# BONNEVILLE LOCK AND DAM ADULT FISH FACILITY IMPROVEMENTS

## OBSERVATION BOXES

SUBMITTAL 01/28/13

**TWO REQ'D. 403C**

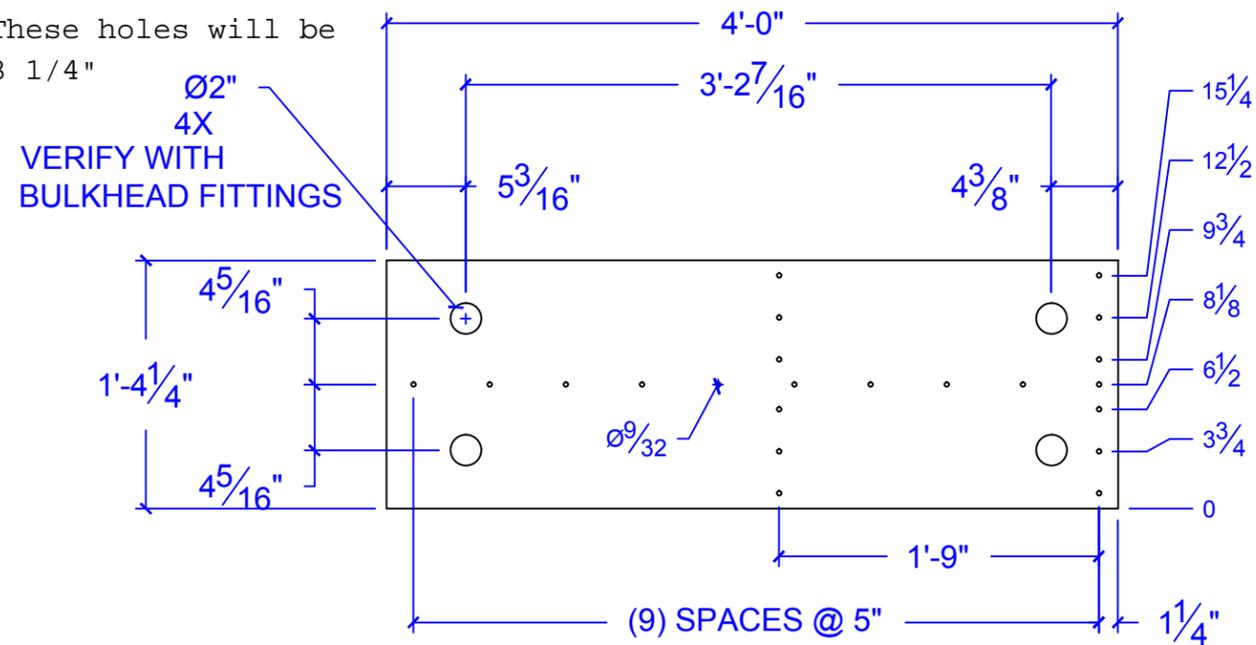
Per RFI 002  
These holes will be  
3 1/4"
